Re: Water Use License 1BR-DYE0409

UMA Engineering Ltd. is submitting the following proposed modifications as per Section H.1 of the existing license. The notification of modifications is being submitted on behalf of Defence Construction Canada and the Department of National Defence.

The following modifications are being proposed as part of the clean up of the DYE-M, Cape Dyer DEW Line site.

PLOT SHOWING ADDITIONAL INFORMATION
FOR CLARIFICATION DURING CLEAN UP
OF CONTAMINATED SOIL AREAS.

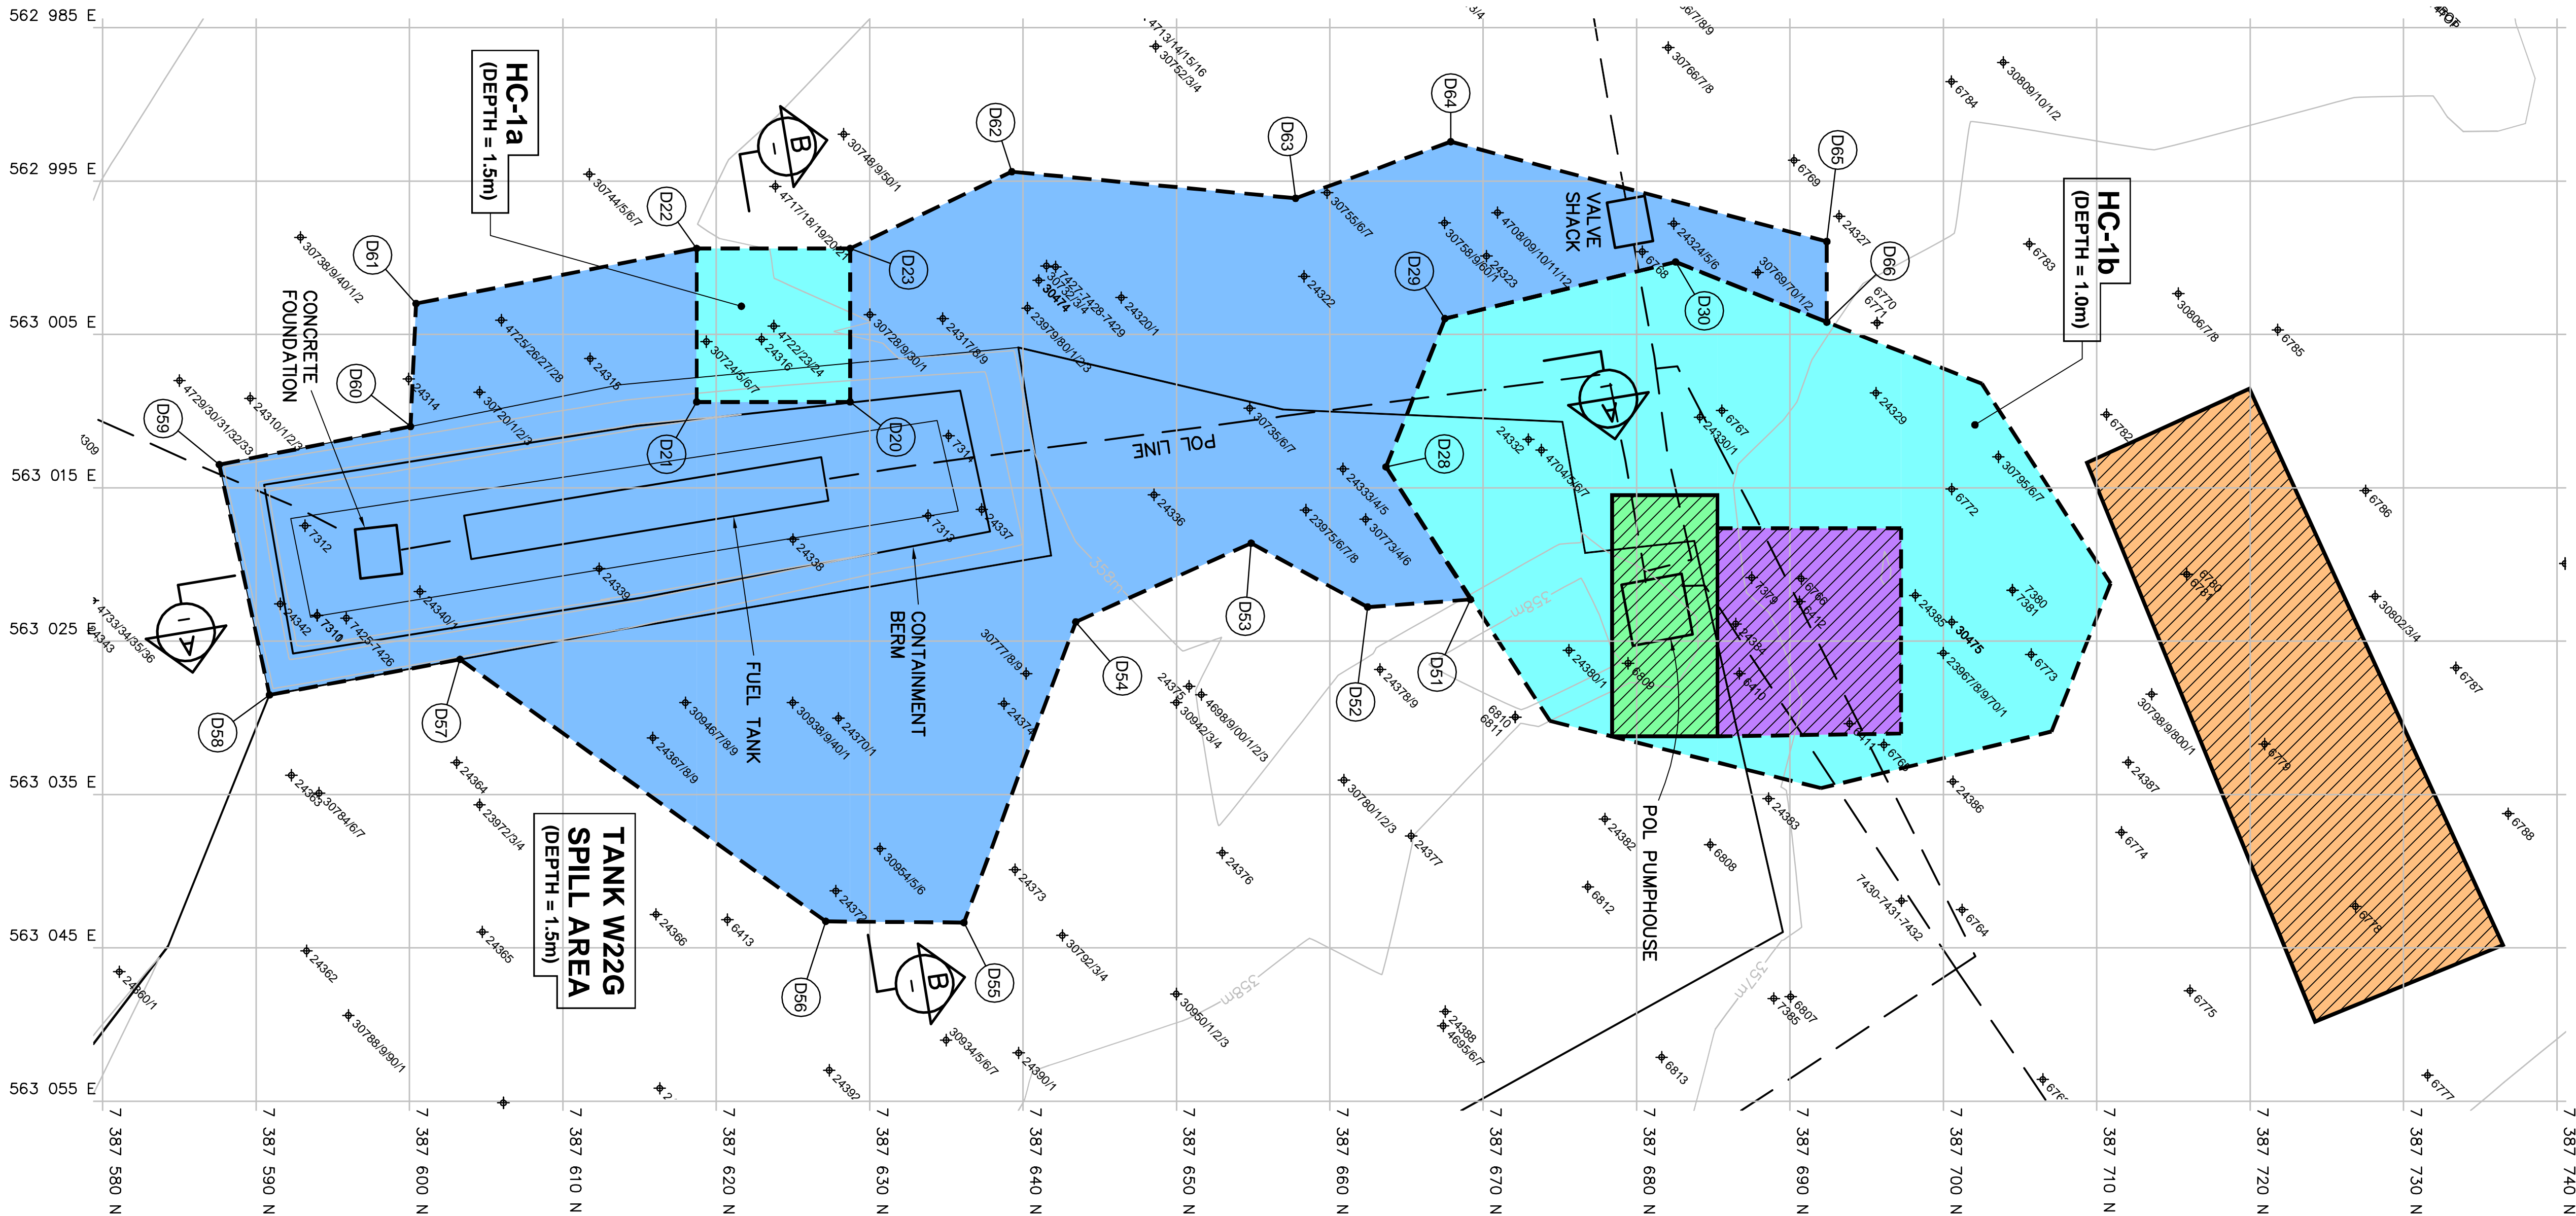
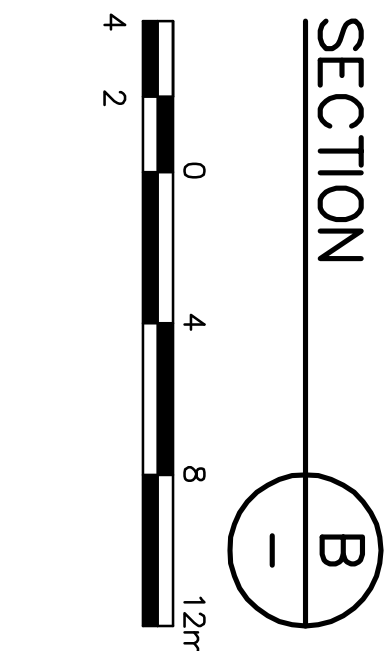
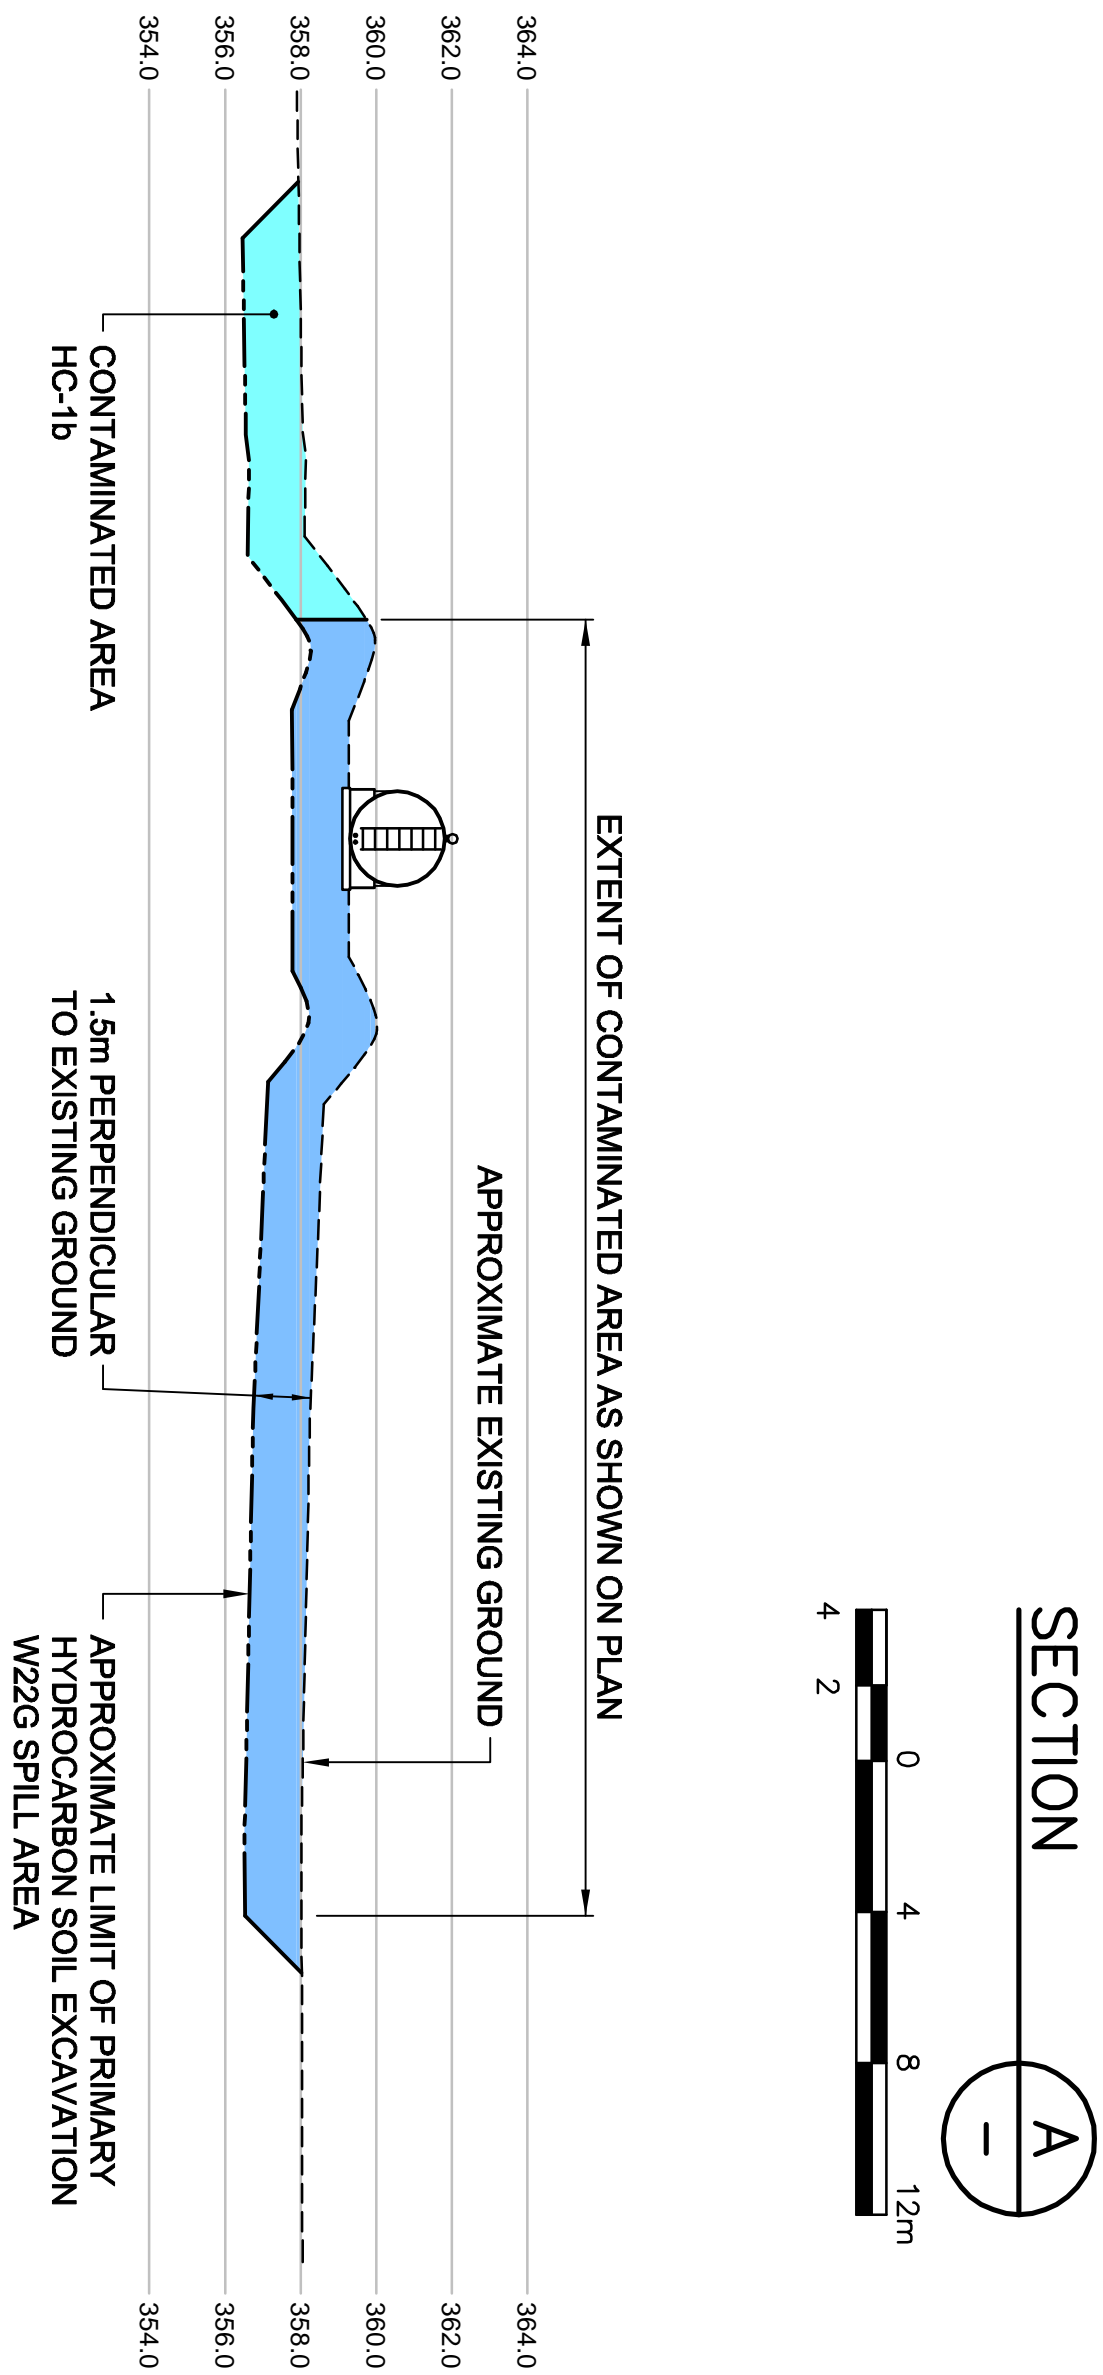
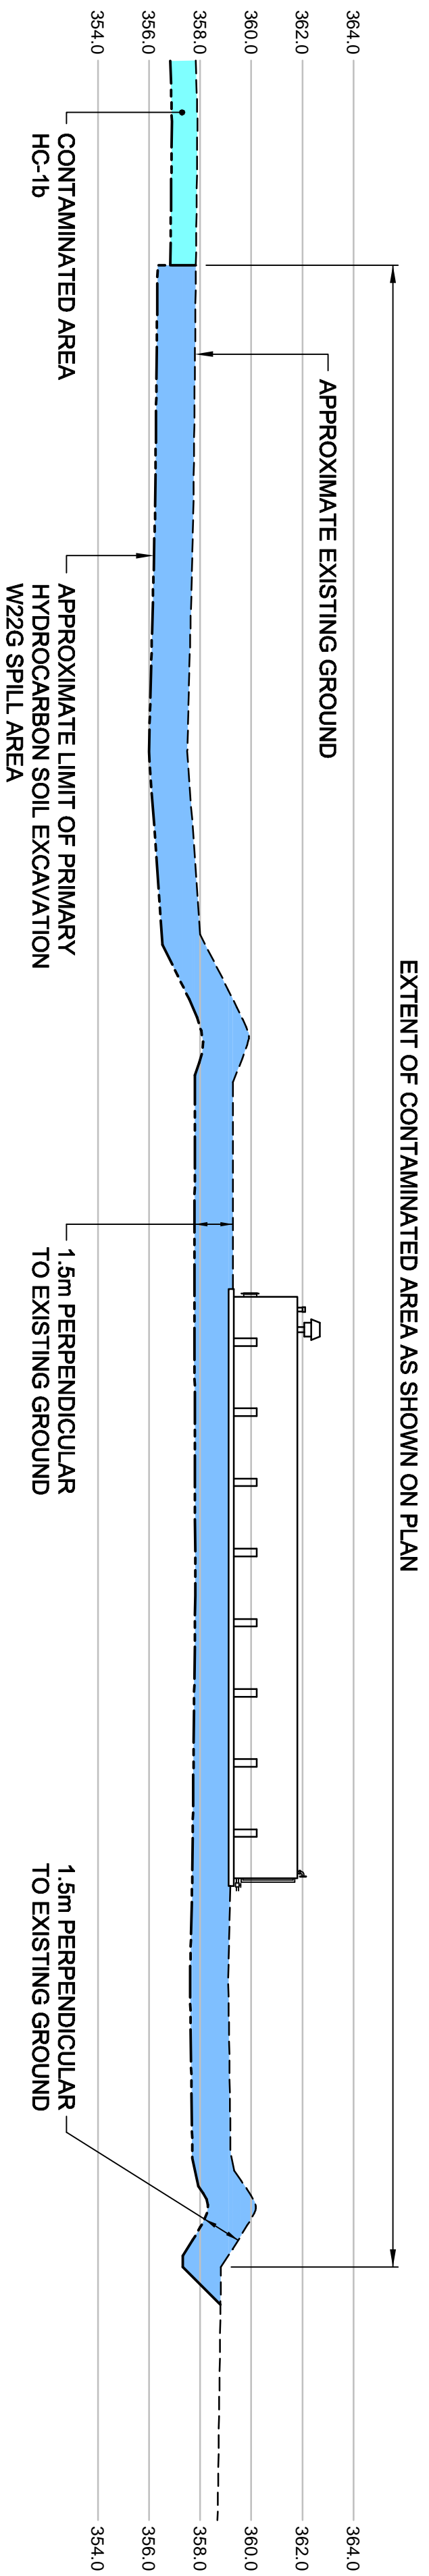
- 3.) On July 9, 2007 a Government of Nunavut Spill report was filed by DCC relating to the release of approximately 52,000 litres of hydrocarbon impacted water from Tank W22G at the DYE-M site. The release of hydrocarbon impacted water and diesel fuel was discharged within the bermed containment and flowed over into the surrounding area, impacting an estimated area of 2,200 m².

A subsurface investigation was subsequently carried out by the Owner to determine the extent of soil impacts resulting from the release. Results from the investigation identified significant petroleum hydrocarbon concentrations in the soil surrounding the containment and adjacent areas. The primary delineated contaminated soil limits requiring remedial excavation, as determined by the 2007 investigation results, are presented in the attached Figure 1.

The excavation of hydrocarbon impacted soils will be completed as early as possible in the 2008 construction season in order to facilitate complete excavation of hydrocarbon impacted soil and minimize further migration of hydrocarbon impacts to the surrounding area. Following contaminated soil excavation and confirmatory sampling, granular fill will be placed from any remaining containment berm into base of excavation. The excavation will be backfilled with Type 3 granular fill, compacted and graded to promote positive drainage and prevent ponding within the excavation area. Any and all free product encountered during contaminated soil excavation will be collected in accordance with hazardous materials collection practises. All water will be tested from within the excavations prior to discharge and will conform to the wastewater discharge criteria.
